In re the Application of: **KURIHARA, Hideo et al.**Serial No.: **10/085,023**Group Art Unit: **2826**Filed: **March 1, 2002**Examiner: **Scott R. Wilson**P.T.O. Confirmation No.: **8810**For. **TWO-BIT SEMICONDUCTOR MEMORY WITH ENHANCED CARRIER TRAPPING (AS AMENDED)****PETITION FOR EXTENSION OF TIME**Commissioner for Patents
P.O. Box 1450
Alexandria, VA 22313-1450

In re the Application of: **KURIHARA, Hideo et al.**Serial No.: **10/085,023**Group Art Unit: **2826**Filed: **March 1, 2002**Examiner: **Scott R. Wilson**P.T.O. Confirmation No.: **8810**For: **TWO-BIT SEMICONDUCTOR MEMORY WITH
ENHANCED CARRIER TRAPPING (AS AMENDED)****AMENDMENT UNDER 37 C.F.R. §1.111**Commissioner for Patents
P.O. Box 1450
Alexandria, VA 22313-1450

U.S. Patent Application Serial No. 10/085,023
Amendment Under 37 C.F.R. §1.111 dated September 23, 2003
Reply to the First Rejection of May 23, 2003

FIG. 8
PRIOR ART

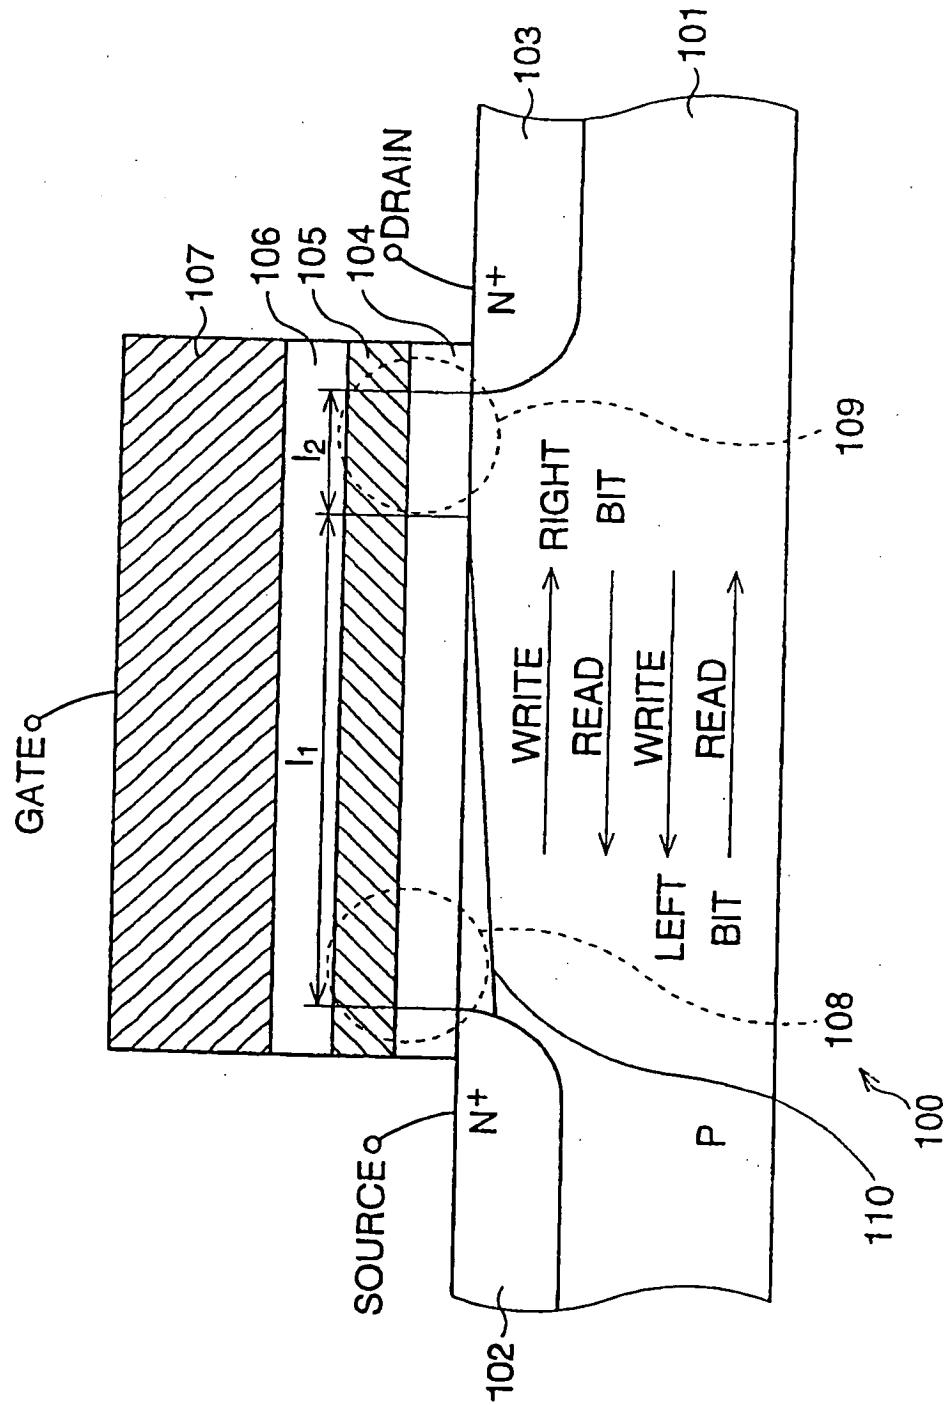
The attached sheet of drawings includes changes to Fig. 8. This sheet, which includes Fig.8, replaces the original sheet including Fig. 8. Amended Fig. 8 has been labeled as prior art as suggested by the Examiner on page 2 of the outstanding Office Action.

The Examiner has required, that Fig. 8 be labeled as prior art. As such, attached herewith is a replacement sheet of drawings including Fig. 8 which has been labeled prior art. Accordingly, withdrawal of this objection to the drawings is respectfully solicited.
